Secondary containment and credible scenarios

Thames text in black, EA response in blue

Figure 4.3 Process for estimating containment capacity

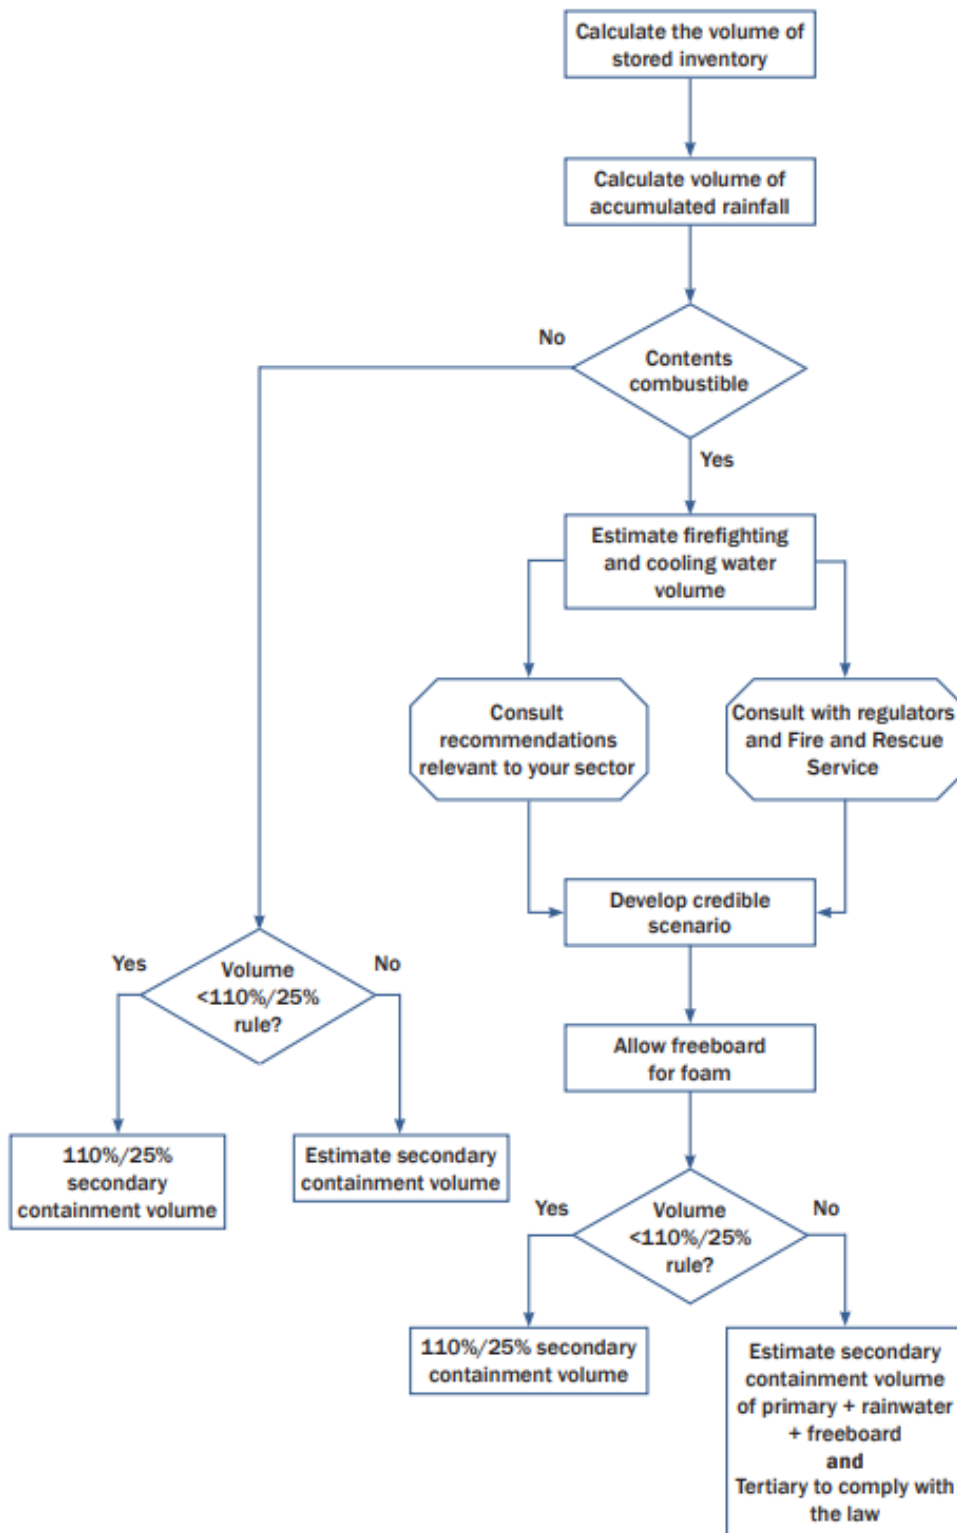
On the contrary the guide is simply recognising that the 110/25% rule, an established industry standard, doesn't follow the risk-based approach recommended in other sections of the guide. In other words the requirement for secondary containment is not dependent on a risk assessment; the requirement cannot be risk assessed away, nor can volumes be reduced. This is also made clear by figure 4.3.

Figure 4.3 reinforces this point. It shows credible scenarios to be relevant only if the contents of a tank are combustible, presumably because the loss of more than one tank is unlikely unless there is a fire or explosion. Again the implication is that credible scenarios can result in the required containment volume being increased but not decreased.
